DEVELOPMENT REVIEW BOARD REPORT

104-DR-1999#2
Desert Cove Medical Office
8960 E Desert Cove Avenue

Request for site plan and elevations approval for an addition to an existing medical complex.

**Stipulations for Case:
Desert Cove Medical Office
104-DR-1999#2**

SOUTH ELEVATION BUILDING 'B'

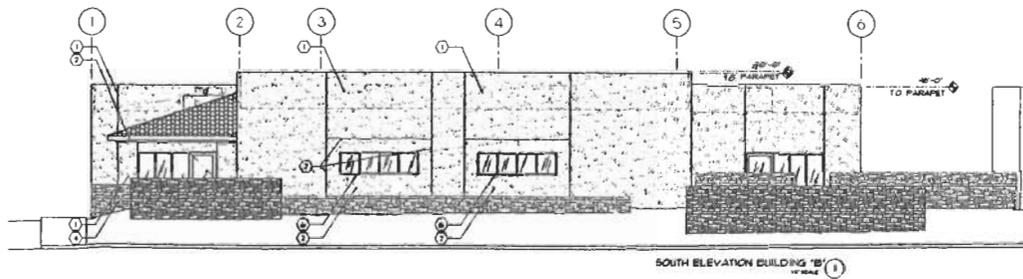
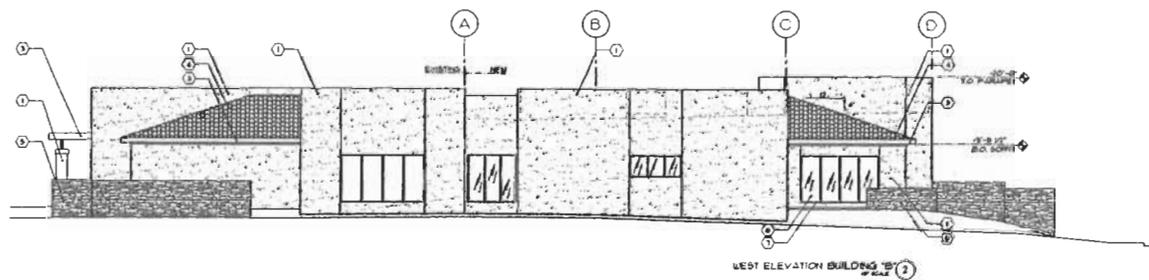
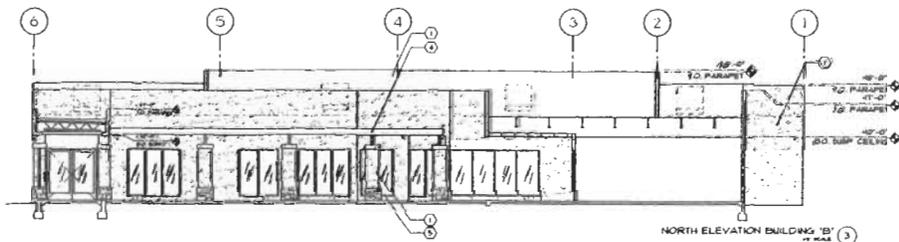
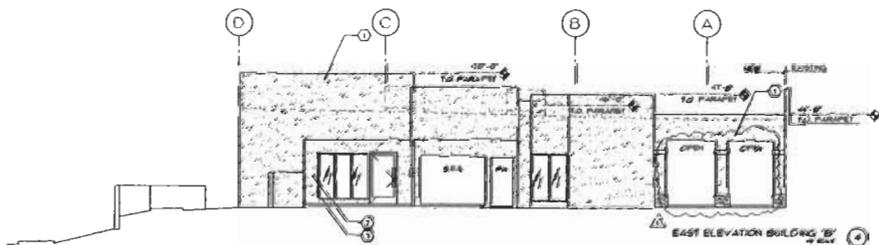
8. Dooley wall fencing shall not be allowed.
9. All walls shall match the architectural color, materials and finish of the building(s).
10. The breezeway connecting the two (2) buildings shall be constructed as an open-air structure and fully open to the outside on at least one side.
